Comments of 802.16 WG on Draft  
“Coexistence Lessons Learned”  
(802.19-14-0080-00)

IEEE 802.16 WG

2014-11-03

Figure 410—CX-Frame structure for CX-CBP

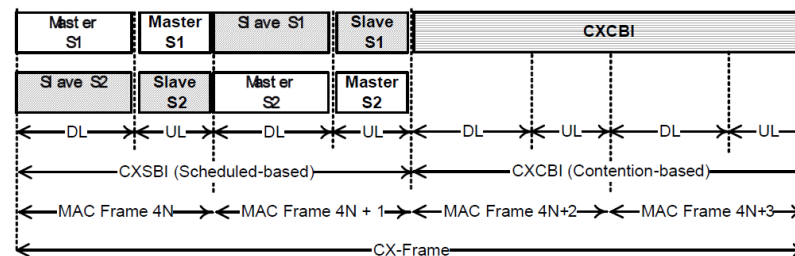
- The 802.16h base station collects information **from the subscriber stations** about interference ~~from the subscriber stations~~
- Candidate Channel and Master Frame Assessment (CCMFA) is used to evaluate candidate channels, based on passive scanning, which ~~has low interference~~ is **non-interfering**
- A coexistence frame (CX-Frame) is introduced which is based on two time intervals
  - Coordinated Coexistence Schedule Based Interval (CXSBI)
  - Coordinated Coexistence Contention Based Interval (CXCBI)
